Response to Submissions LEP Amendments

Waterloo South

Response to Submission Summary

Proposed CSSDA **RtS** LEP Amendments - Height of Building.

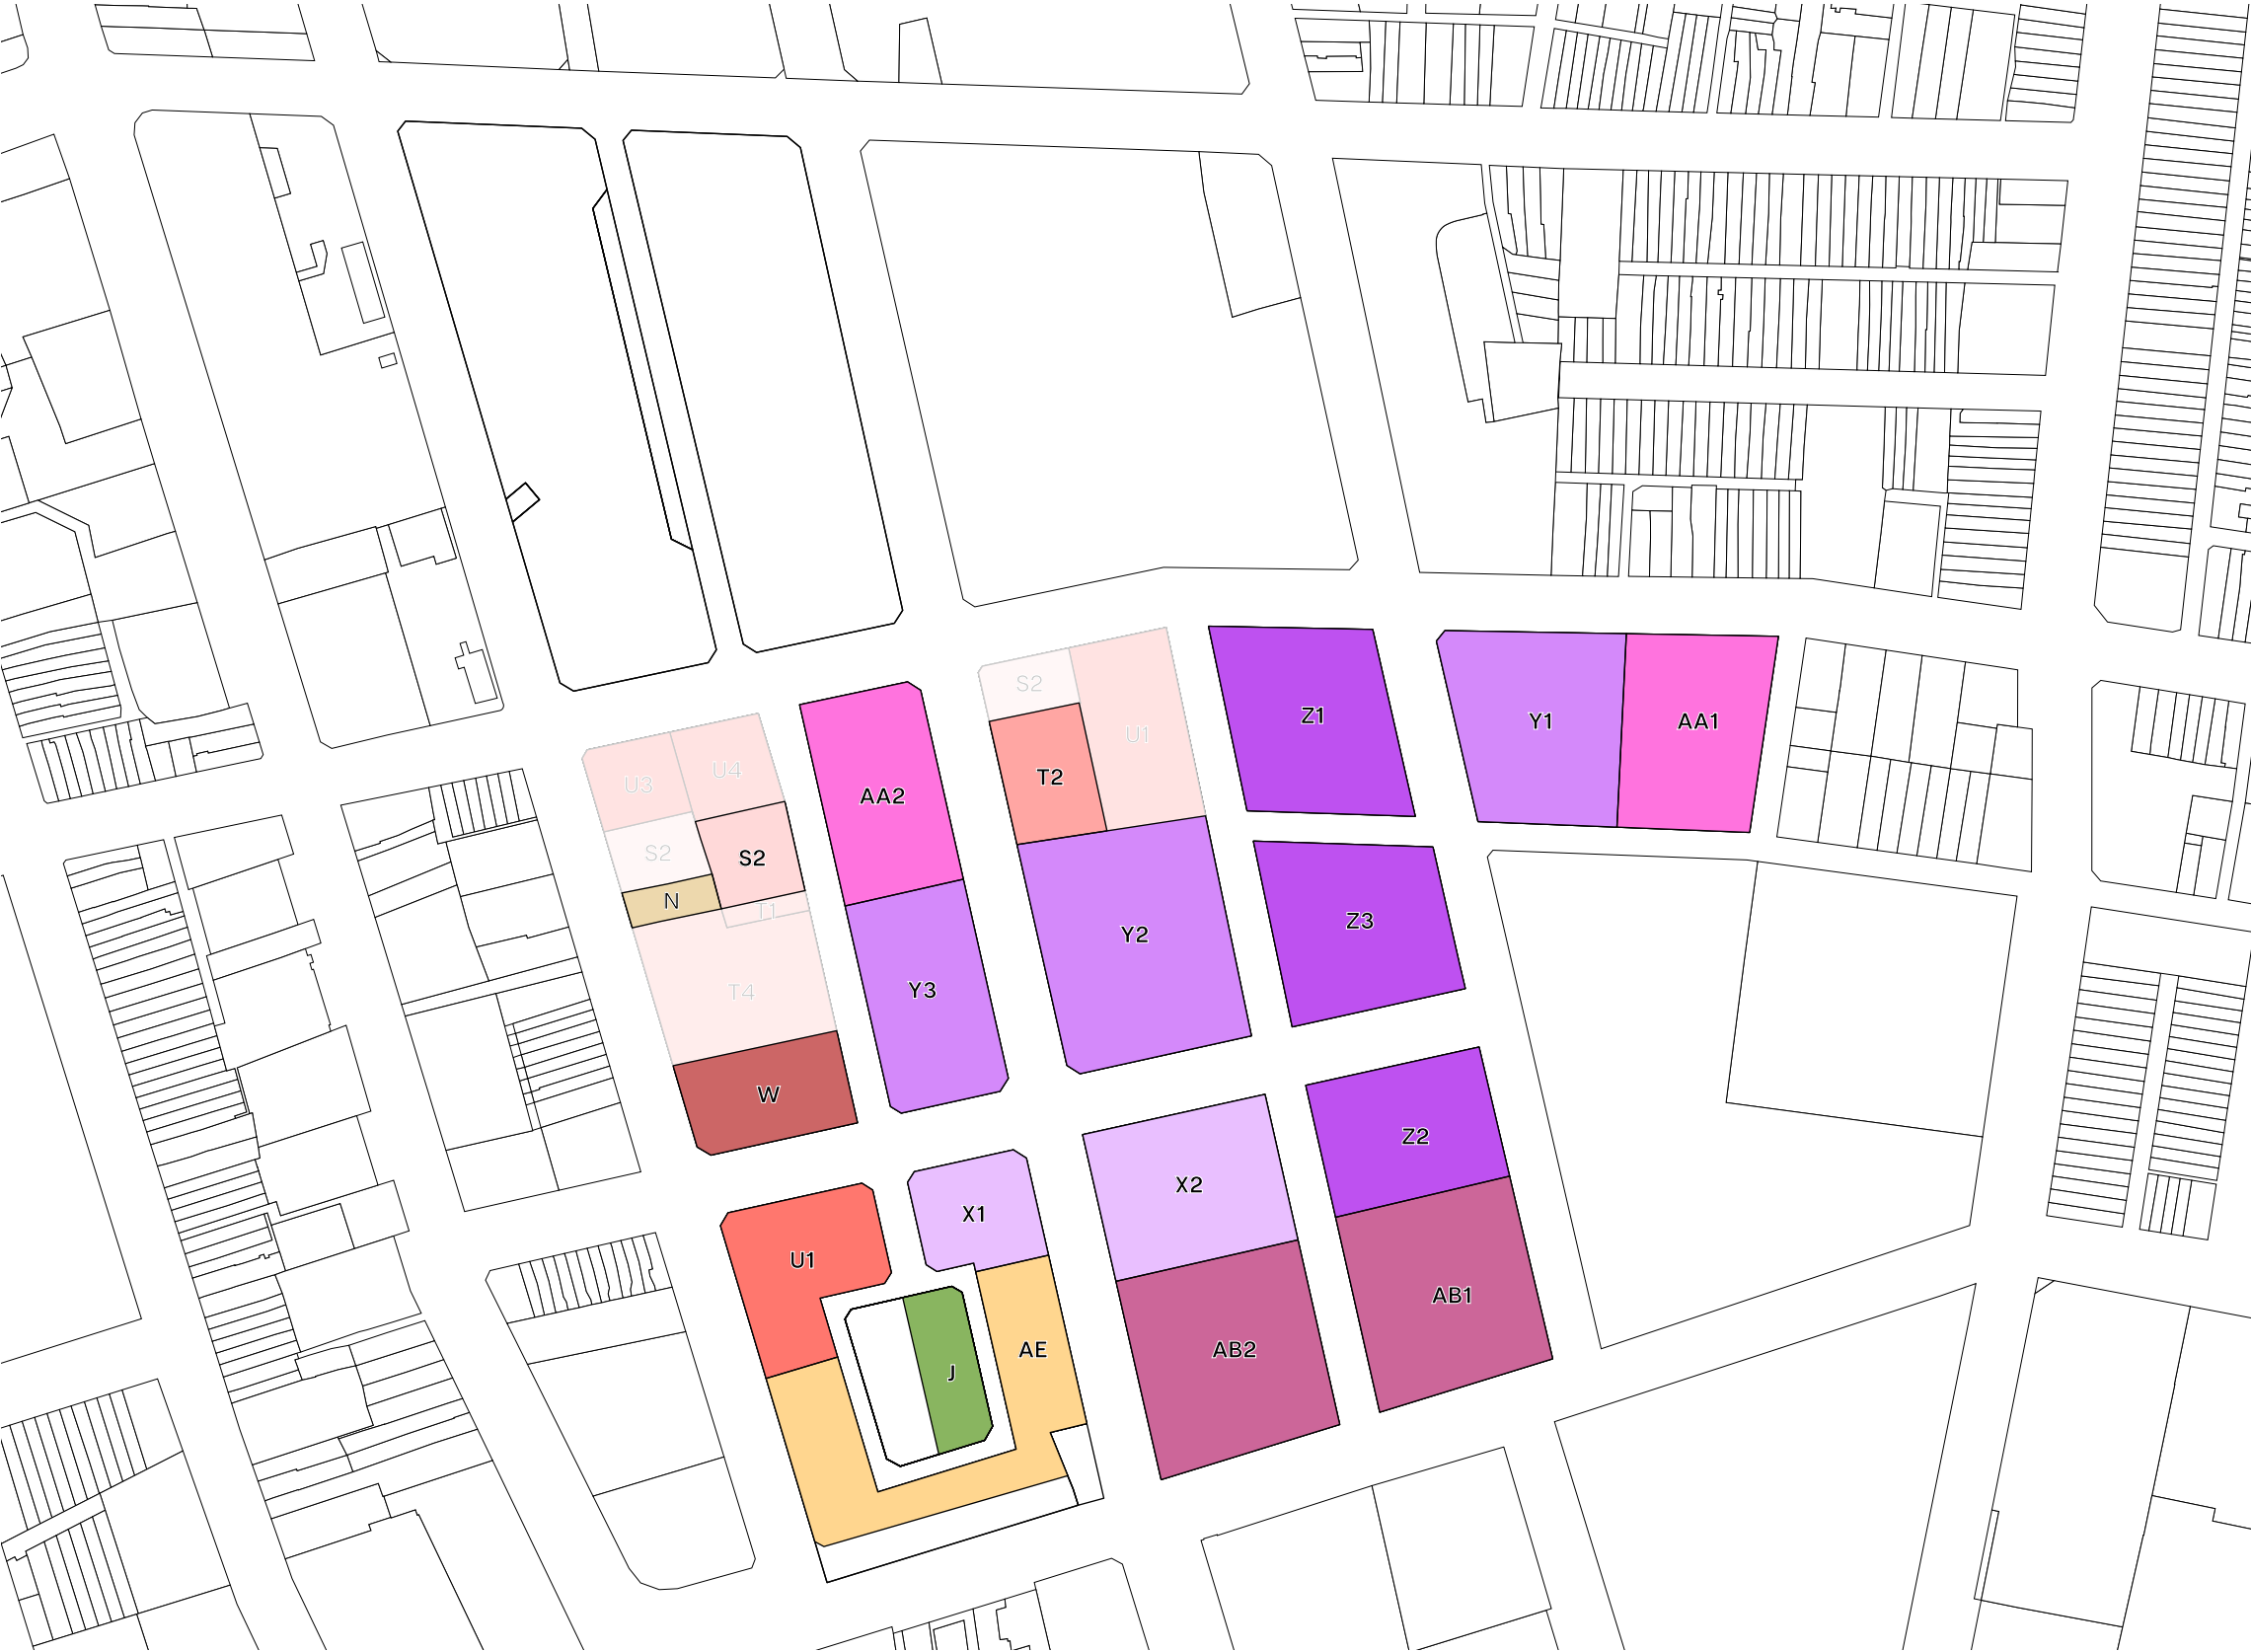
Agency	Summary of Key Issues	Response	Supporting RtS Documentation
LEP Amendments			
City of Sydney	<u>Height of Building</u> Height controls are generally reflective of the concept plan but are too coarse. If the proposed concept envelopes and reference schemes are to demonstrate that future developments are capable of complying with the proposed controls, the proposed heights appear significantly more generous than the maximum yield. In particular, on some sites where there is a 40m difference in height between the LEP control and the reference scheme height.	The revised LEP Height of Buildings controls respond to City of Sydney feedback seeking closer alignment between the planning envelopes and statutory height controls. Amendments are proposed for Buildings 4C, 5A, 6A and 8A, while no changes are proposed for Buildings 2D, 9B and 10A. Retention of the existing controls for Buildings 2D, 9B and 10A is necessary to support ADG compliance, maintain design flexibility and uphold the intended built form outcomes for the precinct. Refer to the supporting RtS documentation for detailed justification of the proposed LEP height amendments.	Pg 4 - 10

CSSDA Proposed LEP HOB	Ref Scheme Height	RtS Proposed LEPHOB
2D	37m	31m	No change from CSSDA.
4C	74m	30m	34m
5A	65m	25m/62m	28m/65m
6A	62m	24m/40m	27m/62m
8A	54m	31m	33m
9B	56m	40m	No change from CSSDA.
10A	39m	25m	No change from CSSDA.

Proposed CSSDA **RtS** LEP Amendments - Floor Space Ratio.

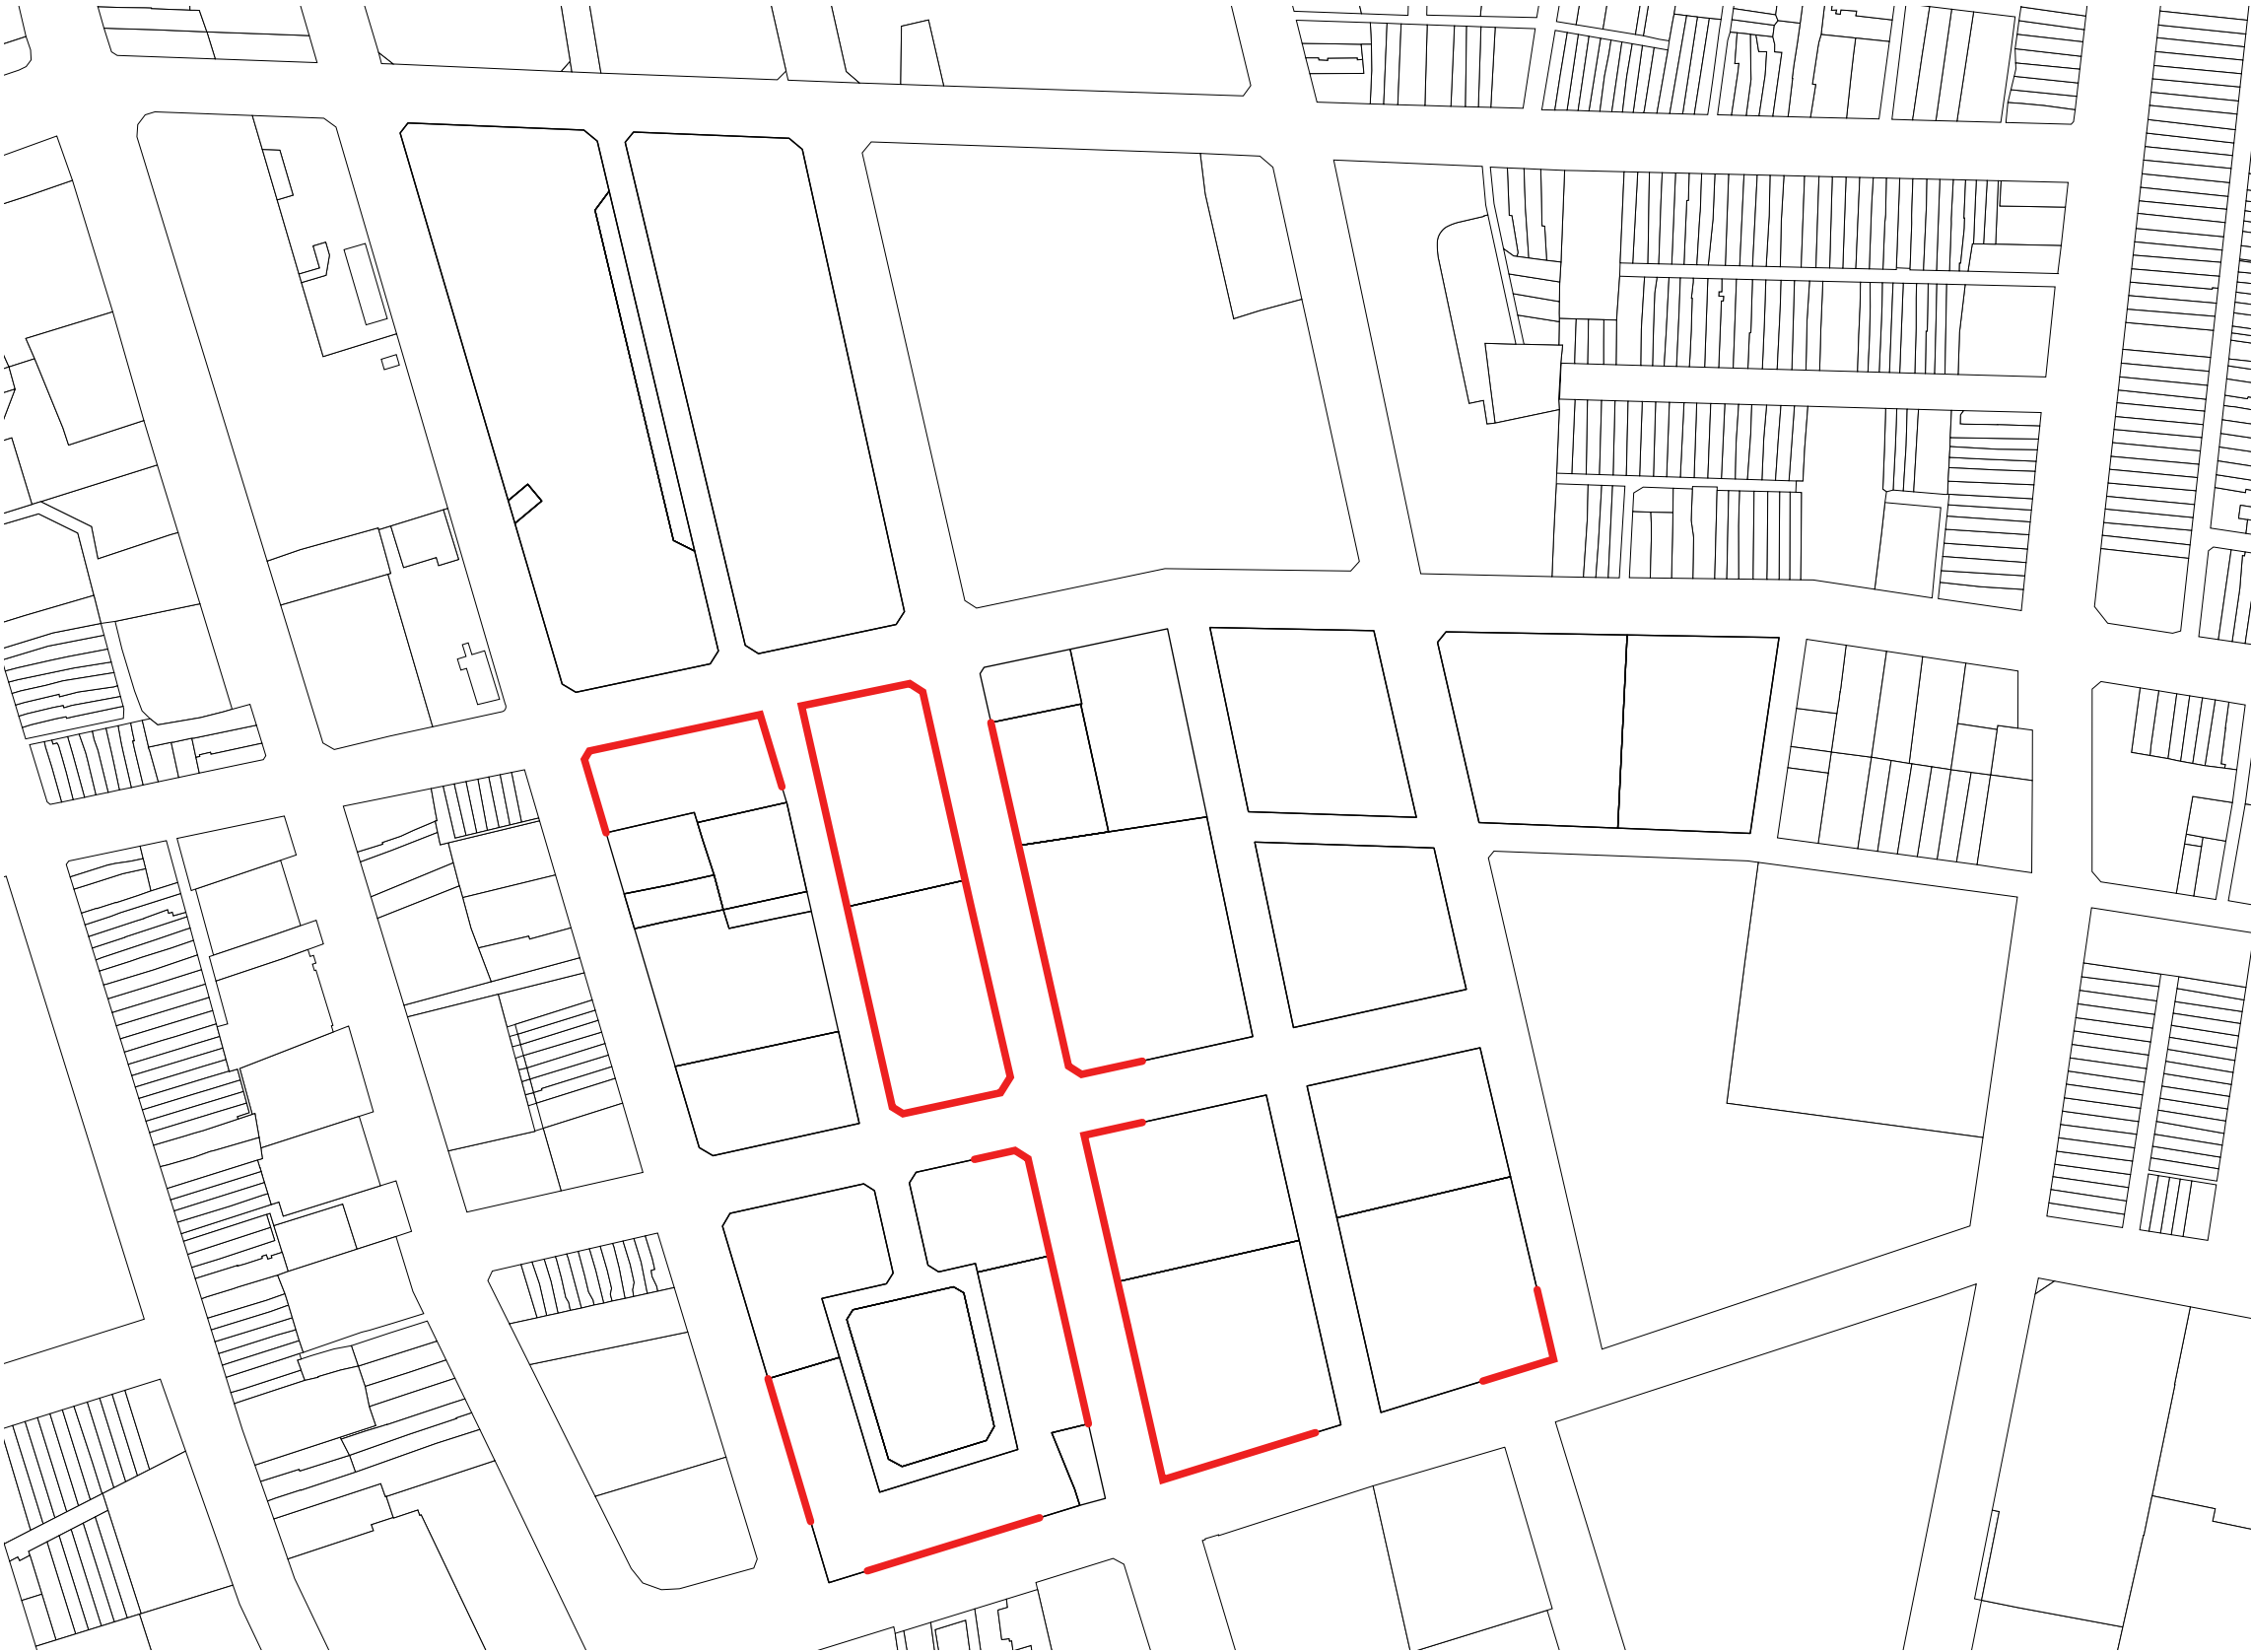
City of Sydney Stockland TfNSW DPHI	<u>Floor Space Ratio</u> There is insufficient information to confirm if the changes to the Floor Space Ratios on the maps are correct and are rationalised in the proposed envelopes and reference scheme. A comparative analysis will assist in confirming this. Further, as the lots have not yet been subdivided, the areas that will become parks it would be prudent to have FSRs of 0:1:1 on Block 1 and Block 8 parks and not be left unrestricted. <u>Reallocation of Non-Resi use in Block 2C</u> Minor adjustments to FSR based on reallocation. <u>McEvoy street Road Acquisition / Road Widening</u> TfNSW seeks to retain the existing road reservation along the northern side of McEvoy Street between Botany Road and Elizabeth Street (i.e. along the McEvoy Street frontage of the site). DPHI also recommends Homes NSW considers the impacts of the reservation mapping on the design and layout of the proposal and update proposed mapping accordingly.	- Revised FSR based on 2C reallocation. - FSR of 0.1:1 added to Block 1 & Block 8 parks. - Revised FSR based on updated Block 9A & 10A areas to exclude the following TfNSW registered titles: — Lot 4 / DP252609 — Lot 5 / DP252609 — Lot 6 / DP 252609
